Tice River Homes Legacy

model
36-04

project #
17052

REAR ELEVATION 'A' & 'B'

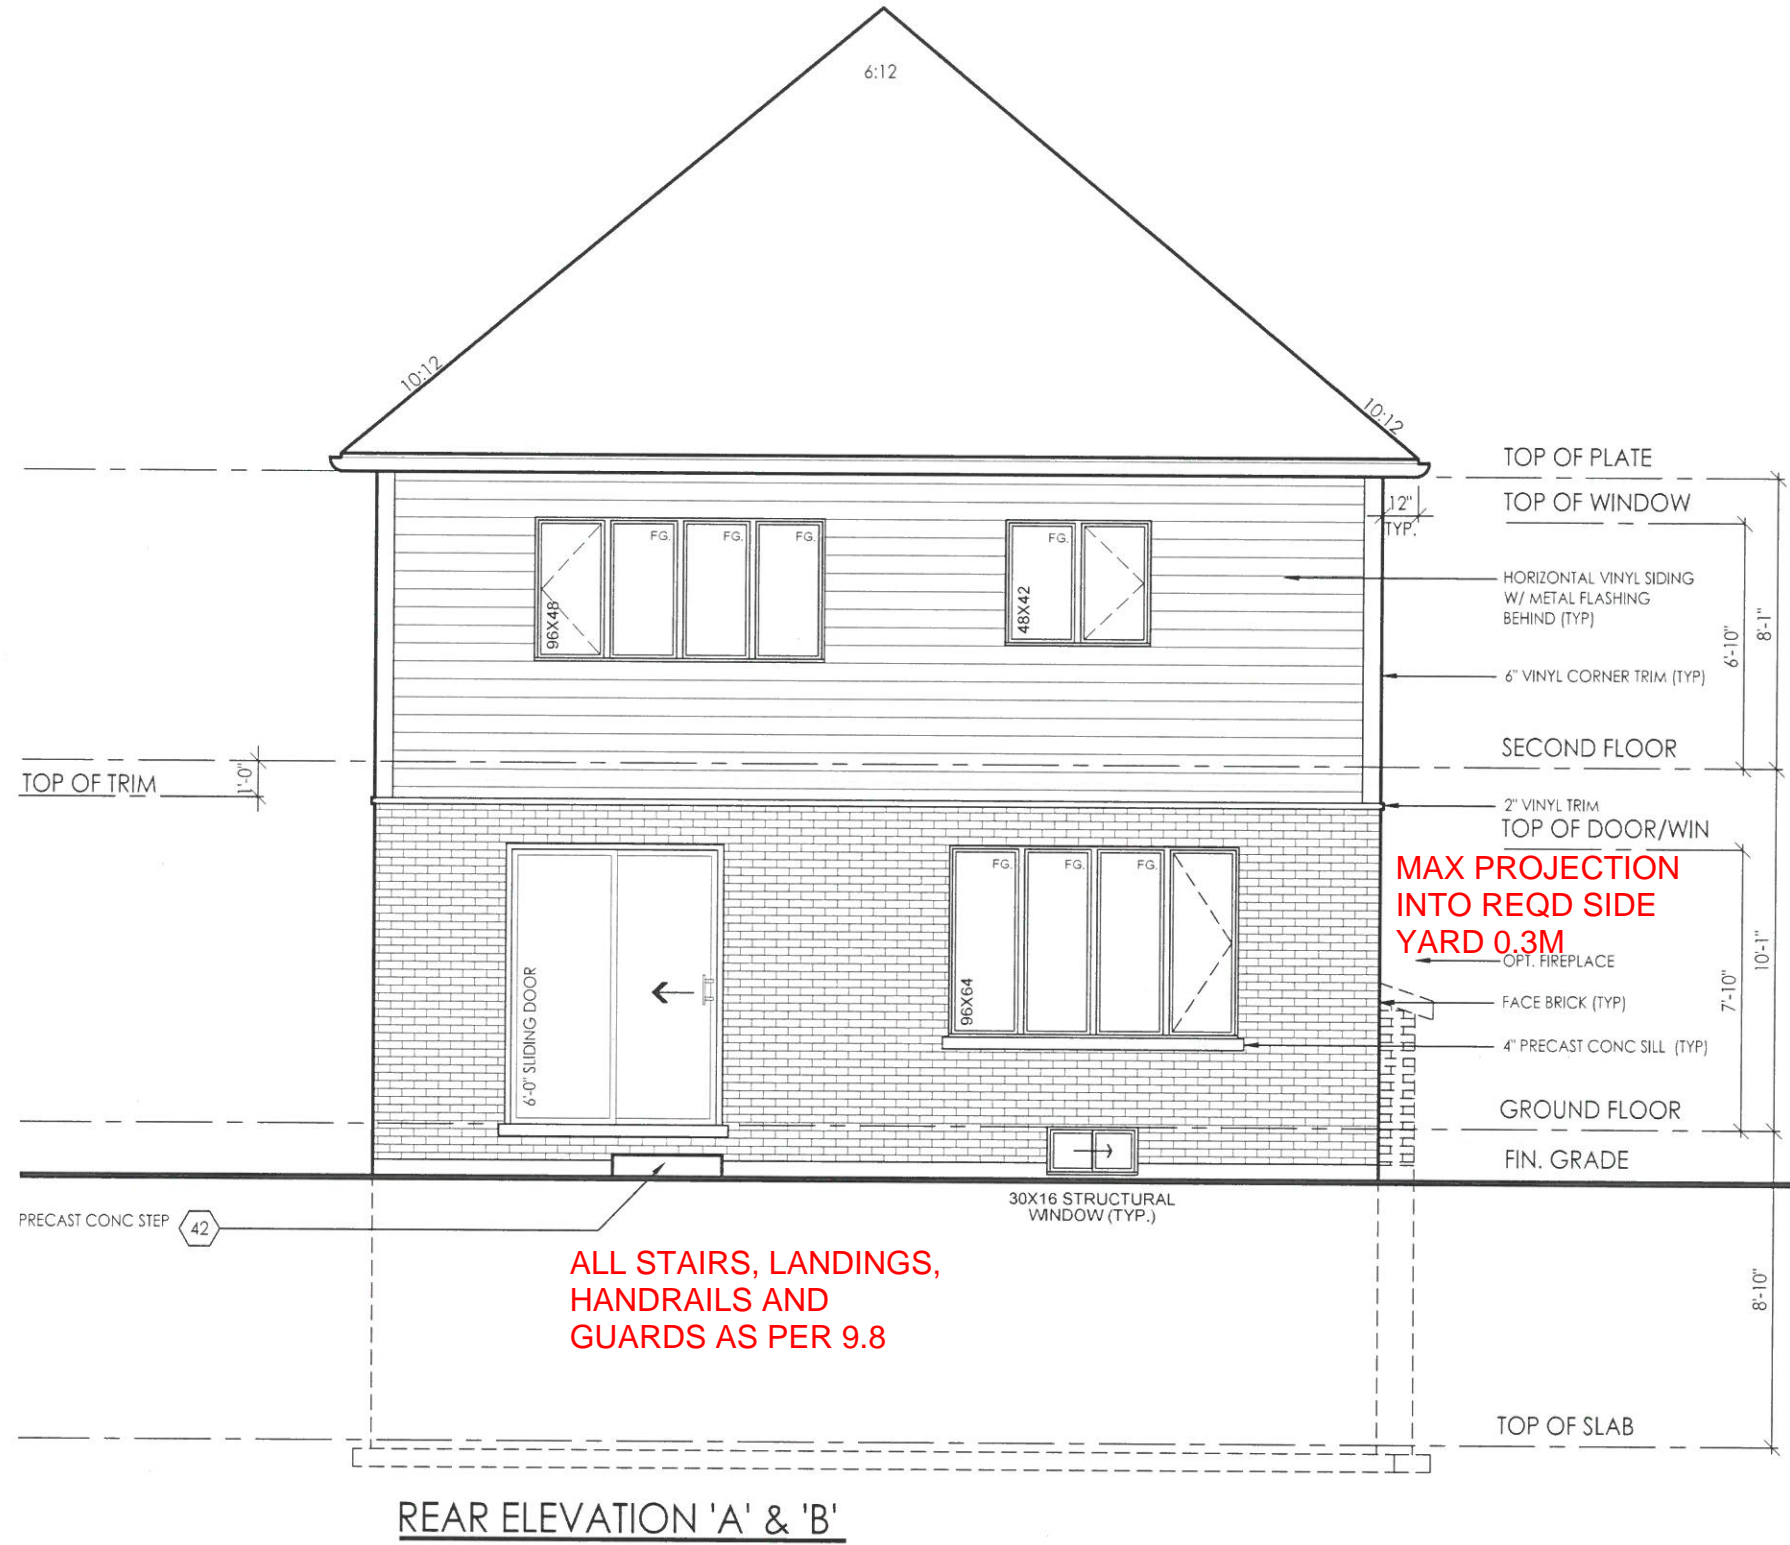
ALL STAIRS, LANDINGS,
HANDRAILS AND
GUARDS AS PER 9.8

MAX PROJECTION
INTO REQD SIDE
YARD 0.3M
